## **Explanation of Significant Difference for the Revision 1 Record of Decision Remedial Alternative Selection for the Wetland Area at Dunbarton Bay in Support of Steel Creek Integrator Operable Unit (U)**

**SRNS-RP-2022-00982**

**Revision 1**

**April 2023**

**Figure 3. Location of Additional Ash, Existing Sign Locations, and Existing Land Use Control Boundary**

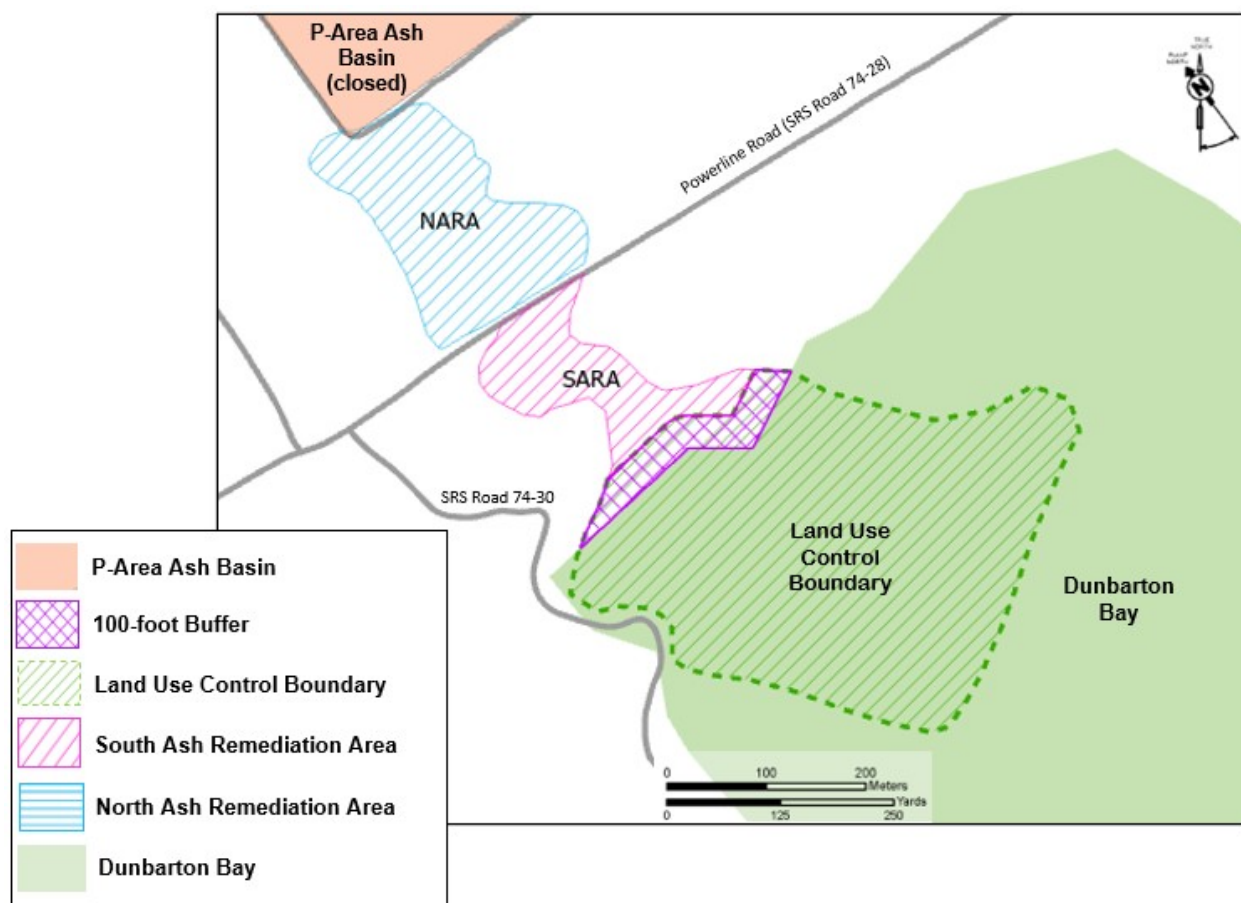
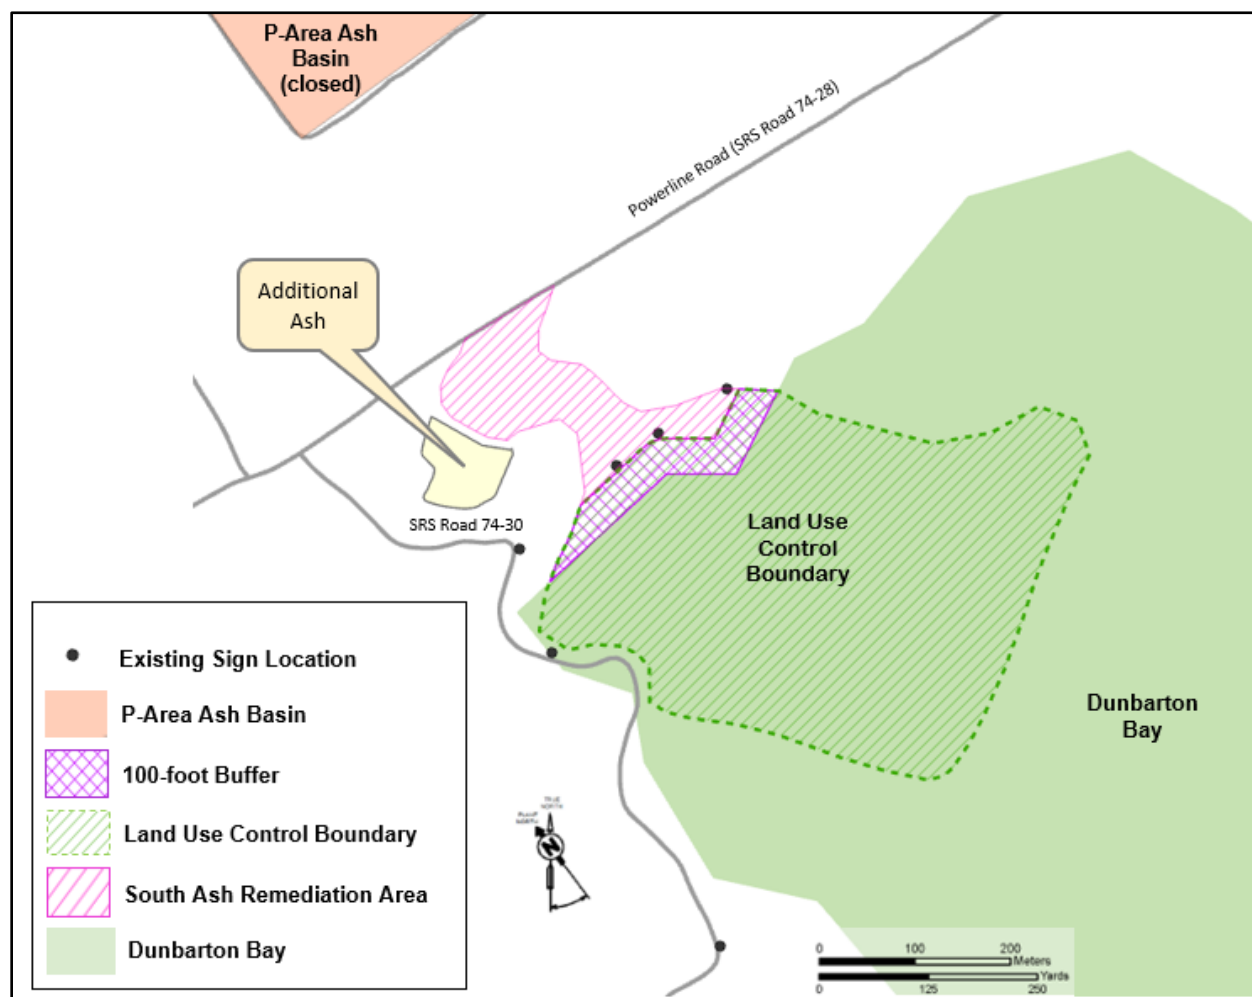
The ROD for the WADB (SRNS 2018a) employed LUCs for 10 ha (25 ac) since the entire volume of waste was not to be excavated and some material would be left in place. The initial LUC boundary is shown in Figure 2. The purpose of this ESD is to document expanded LUCs that include the SARA, the additional ash discovered outside of the SARA, as well as the initial LUC boundary protective of and within the Dunbarton Bay.

**Figure 4. Expanded Area Subject to Land Use Controls**

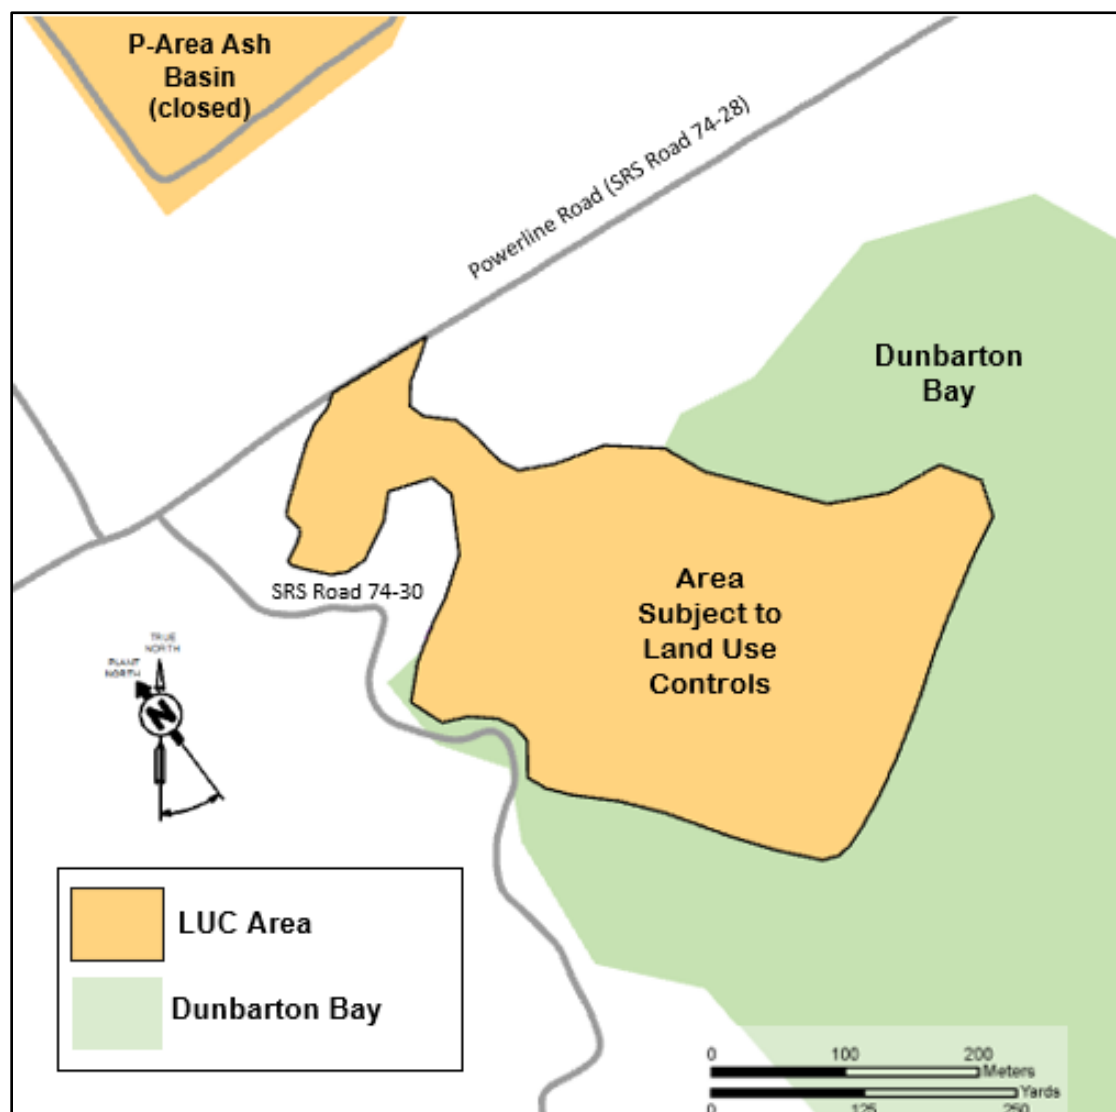
The remedial action addressed in this ESD requires an expanded LUC boundary for the WADB beyond the initial LUC area established for Dunbarton Bay. The expanded LUCs are being implemented to include the ash deposits remaining in the SARA and the additional ash discovered outside of the boundary of the SARA

(Figure 4). LUCs include both institutional controls (i.e., excavation permit restrictions, deed restrictions, health and safety plans for entry, etc.) and physical access controls (i.e., physical barriers, warning signs, no trespassing signs, access controls, and/or fencing, etc.) to minimize the potential for human exposure to contaminants by limiting land access or resource use.

The ROD for the WADB was issued June 20, 2018 (SRNS 2018a). The significant difference described in this ESD is to expand the LUC boundary to include the SARA and additional ash to the east of the SARA. Expansion of the LUC boundary will be protective of human health and the environment without additional excavation and disposal of the ash. The additional ash is located between Powerline Road and Dunbarton Bay (Figure 3).

The actions described herein are documenting an expanded LUC boundary for the WADB from Powerline Road to the 30-m (100-ft) buffer along the northern edge of Dunbarton Bay. The LUC boundary maintains the previously designated LUC area within the 30-m (100-ft) buffer and within Dunbarton Bay (Figure 3). The entirety of the expanded LUC boundary consists of ~16 ha (~39 ac) (Figure 4). The expanded LUCs are estimated to cost approximately \$50,000. It is estimated that pursuing continued excavation and offsite disposal of the SARA and additional ash would cost approximately \$5.8 Million due to the saturated field conditions along with an escalation factor from 2019 to 2023 dollars. This additional cost would result in a total remedial cost for the WADB that exceeds the ROD estimate.
